DART MARINE PARK

UNIT A GENERAL ARRANGEMENT

FOR TENDER - NOT FOR CONSTRUCTION

Original design development: Glo Renewables. Markups show the proposed tender basis; they do not indicate Glo approval of changes.

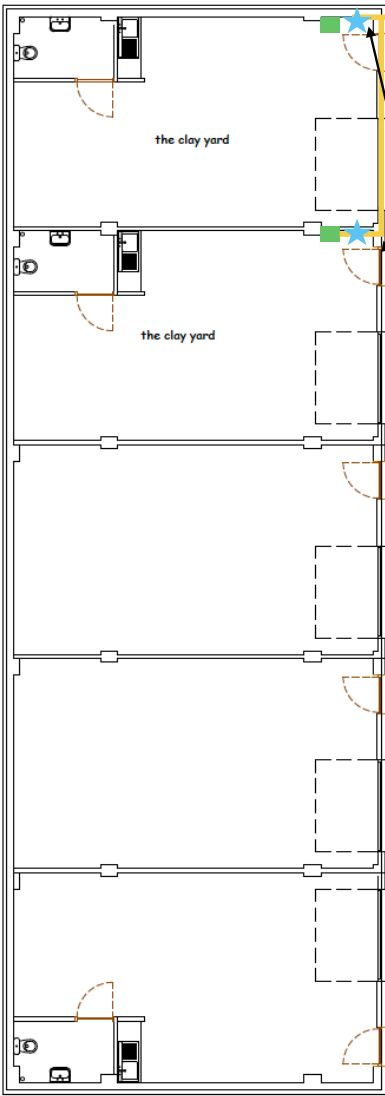
- 01
- One PV connection behind the existing A4 supply meter. A5 remains electrically independent. Do not connect the two supplies together.
- 02
- Existing plan retains building context, supply locations and indicative cable route. Verify A4 identification and final cable route on site.
- 03
- Existing two-supply connection notes and inset schematic are superseded by DMP-SLD-A-001.
- 04
- Tenderers shall select and price the inverter configuration and enclosure arrangement in accordance with the RFT and Appendix C.

Indicative location retained. Select inverter configuration and develop the enclosure in accordance with Appendix C.

SUPERSEDED CONNECTION NOTES

Connect PV to A4 only. A5 remains electrically independent. Cable route remains indicative.

SUPERSEDED ELECTRICAL SCHEMATIC

Refer to DMP-SLD-A-001.

UNIT B GENERAL ARRANGEMENT

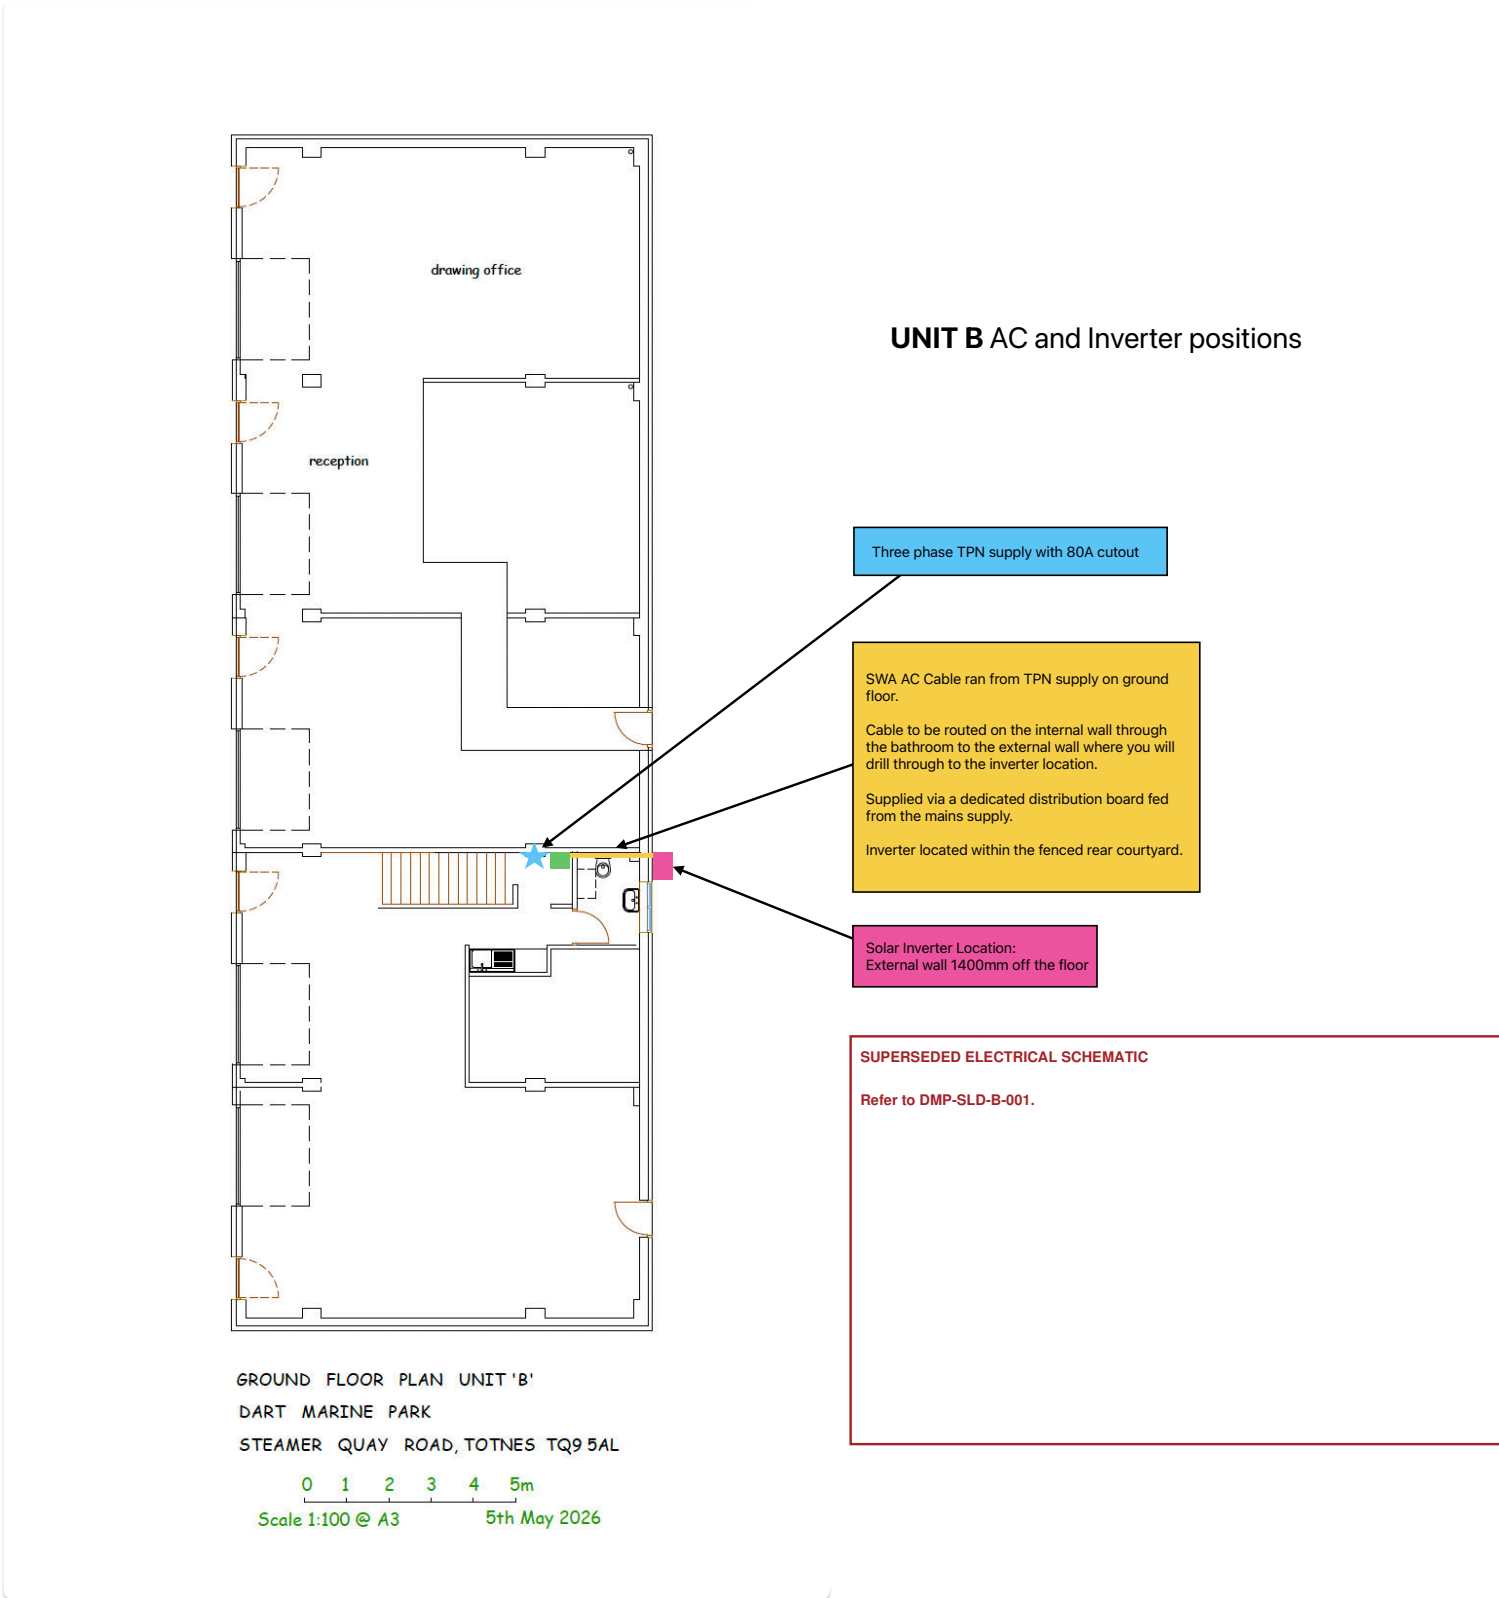
- 01
- Retain the indicative supply point, route through the building and external inverter position in the rear courtyard.
- 02
- Inset electrical schematic superseded by DMP-SLD-B-001. Metering, equipment ratings and protection require confirmation.
- 03
- The inverter position and mounting height are indicative and subject to site verification. Include the enclosure, supports and maintenance clearances required by Appendix C.

UNIT C GENERAL ARRANGEMENT

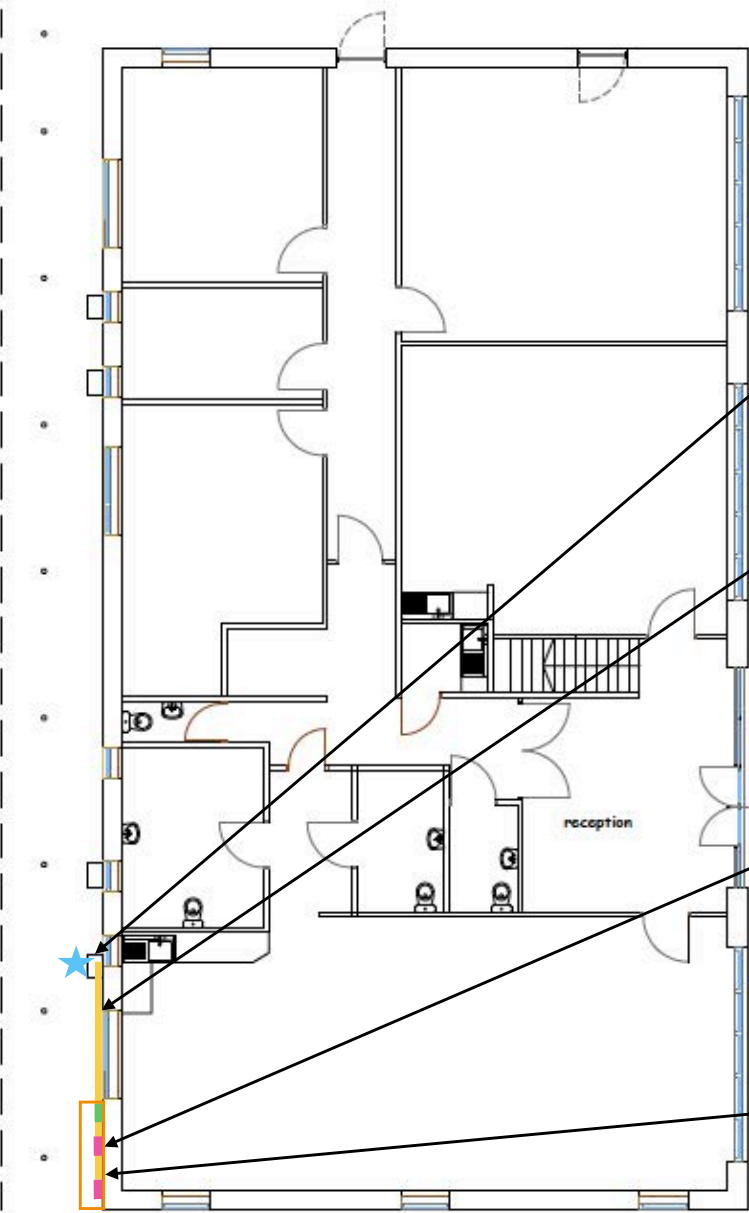
- 01
- Two independent supplies, each serving a separate PV inverter system. C2 / C3 identifiers and physical supply positions require verification.
- 02
- The source plan shows only one supply location. It does not establish the route from the second supply; both routes must be coordinated.
- 03
- The original one-meter / two-inverter schematic is superseded by DMP-SLD-C-001.
- 04
- Existing enclosure construction notes are superseded by Appendix C. Tenderers shall verify the space and access required for their proposed arrangement and identify any constraints requiring TRESOC resolution.
- 05
- Common physical enclosure, if adopted, must preserve separation and safe access for both independent systems.

SUPERSEDED ENCLOSURE DETAIL

Indicative location retained. Develop fire performance, construction, dimensions and ventilation in accordance with Appendix C.

UNIT D GENERAL ARRANGEMENT

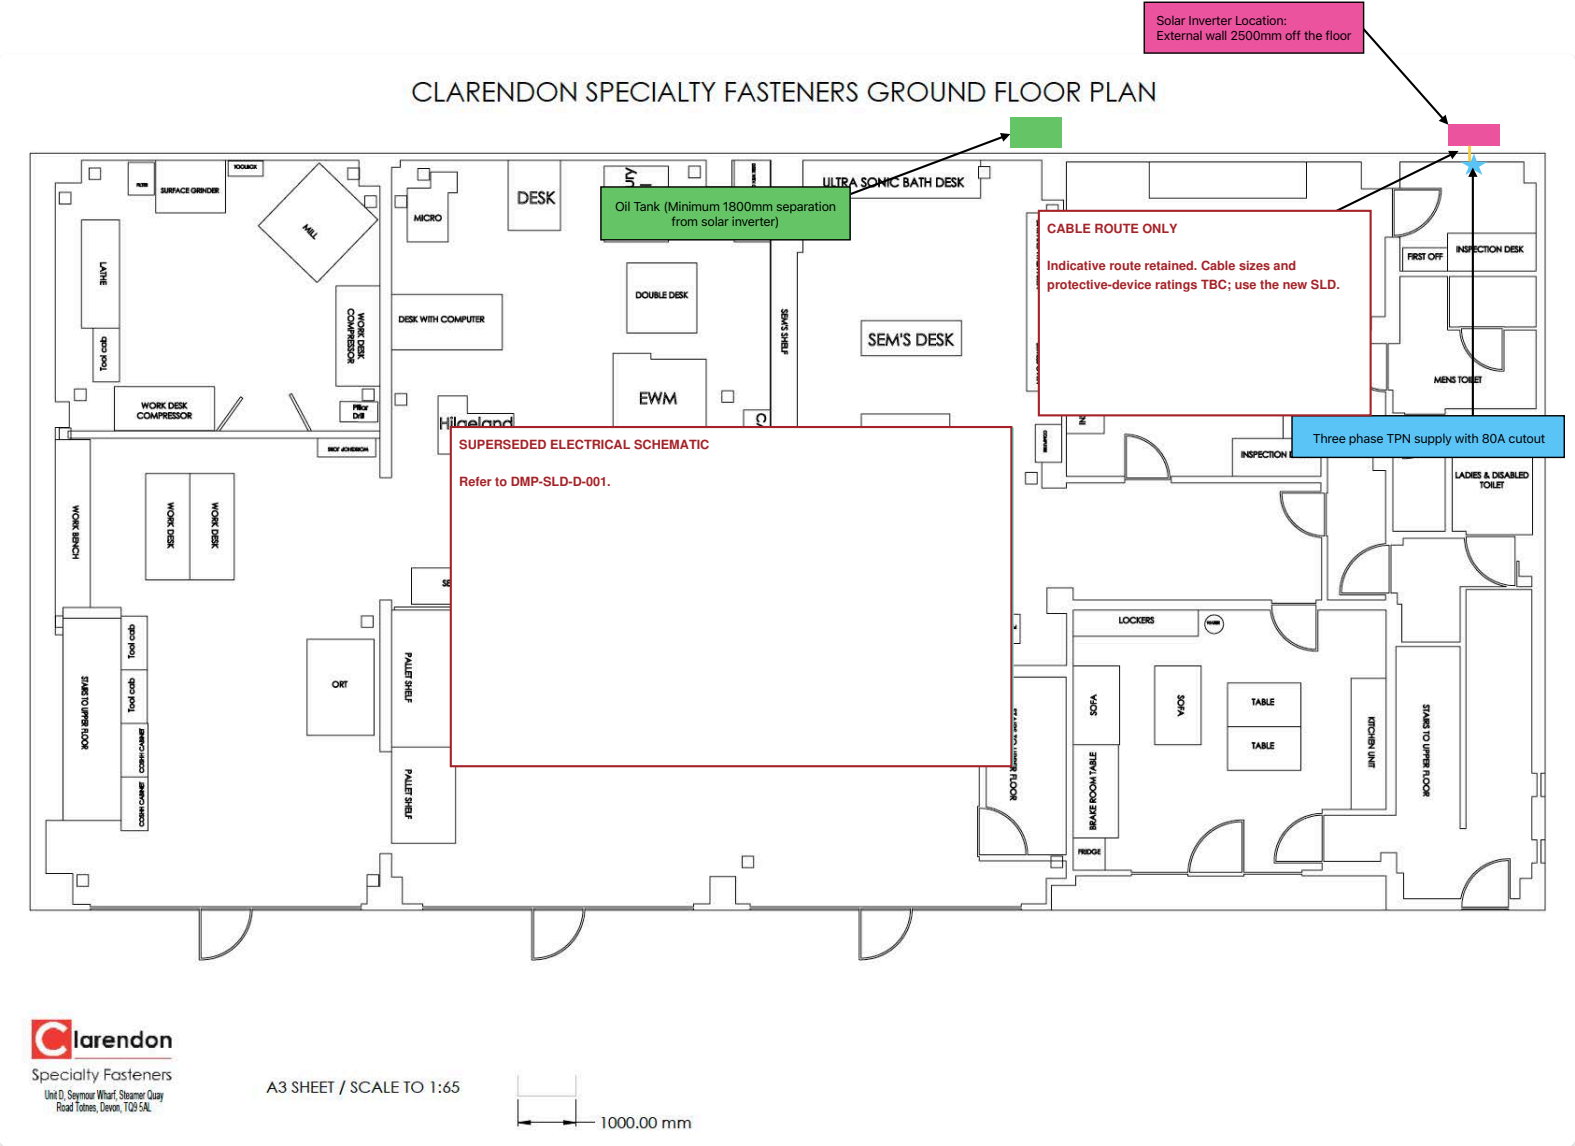
- 01
- Retain the indicative supply position, external inverter position and route through the wall.
- 02
- Inset electrical schematic superseded by DMP-SLD-D-001. Historic cable sizes are not carried forward as confirmed design values.
- 03
- Source identifies an oil tank and 1,800 mm minimum separation. Verify the required separation and actual site arrangement before final design.
- 04
- Verify mounting height, maintenance access and cable containment. Include the enclosure and supports required by Appendix C.
